### ADDENDUM NO. 1

DATE: July 13, 2018

Project: ROBBINS LIBRARY EXTERIOR ENVELOPE REPAIRS 700 MASSACHUSETTS AVENUE TOWN OF ARLINGTON, MASSACHUSETTS, BID NO. 18-16 CBI JOB NO.: 17152

# WEST EXTERIOR ELEVATION

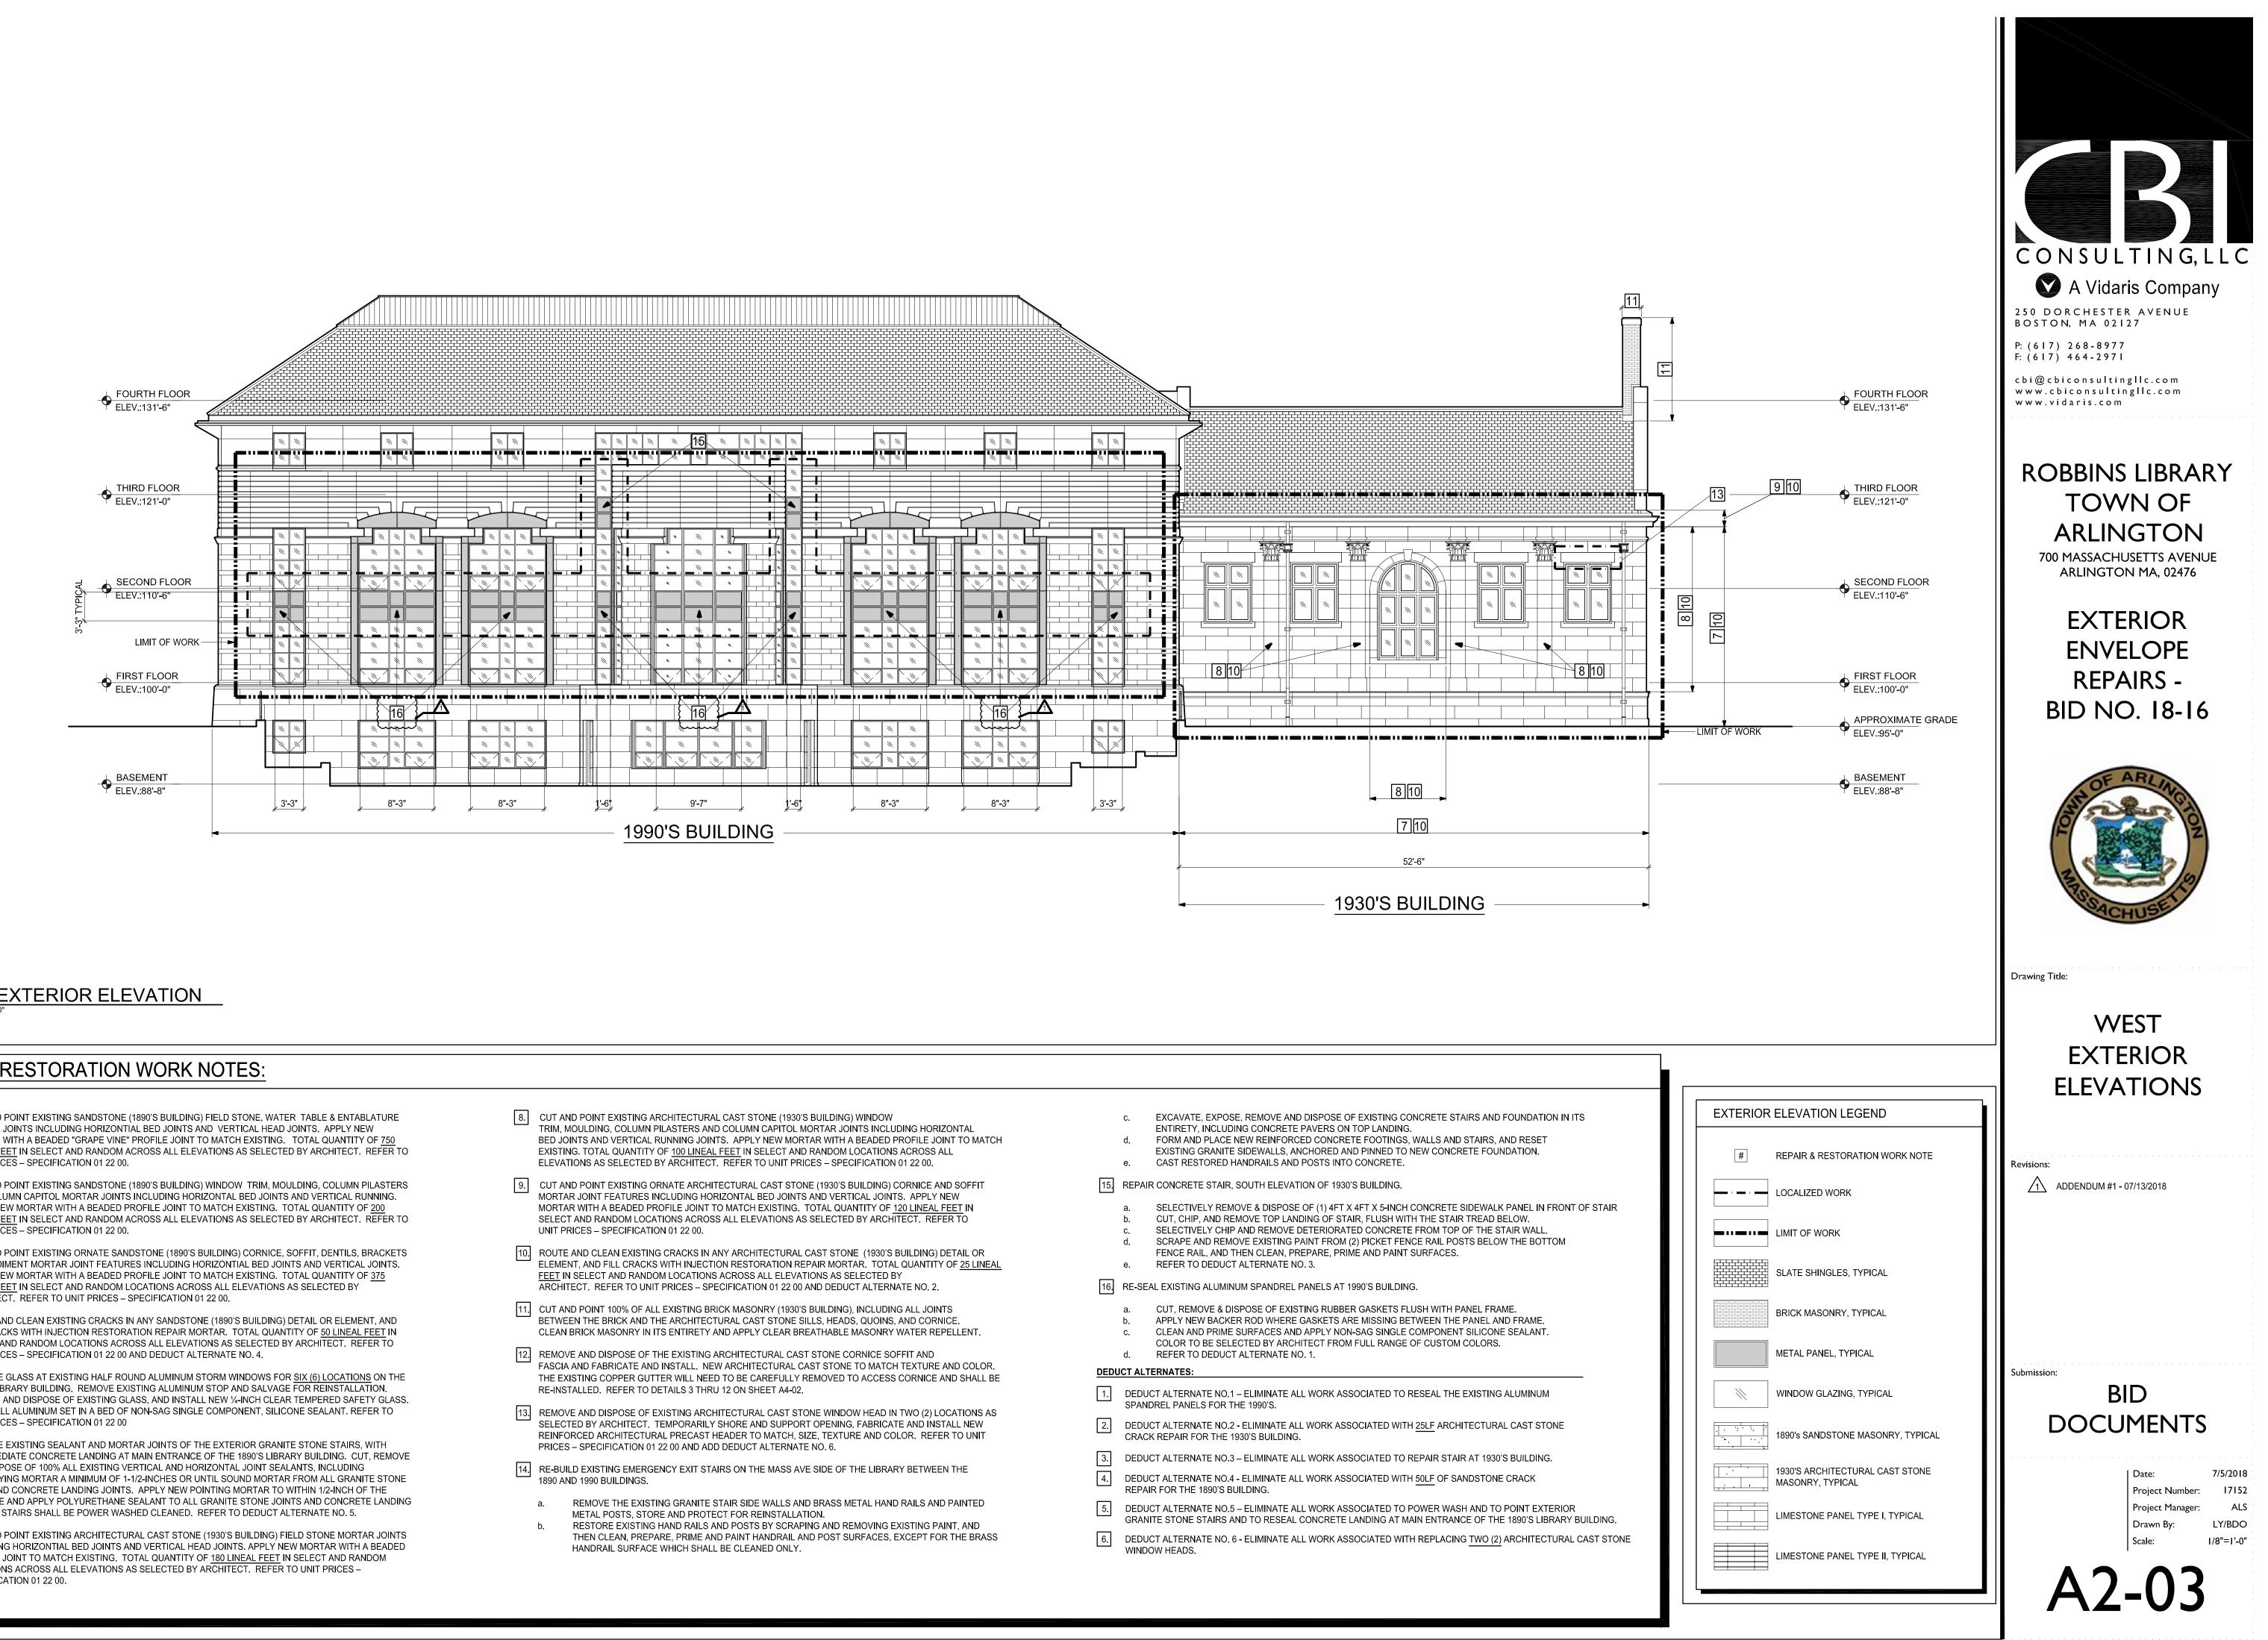
- 2.1 DELETE: DRAWING A2-03 INSERT: DRAWING A2-03 Addendum No. 1 of 07/13/18 (ENCLOSED) SUMMARY: Revise Note Identification on Elevation Drawing for work at Spandrel Panels on the 1990's Building from 15 to 16.
- 2.2 DELETE: DRAWING A2-04 INSERT: DRAWING A2-04 Addendum No. 1 of 07/13/18 (ENCLOSED) SUMMARY: Revise Note Identification on Elevation Drawing for work at Spandrel Panels on the 1990's Building from 15 to 16.
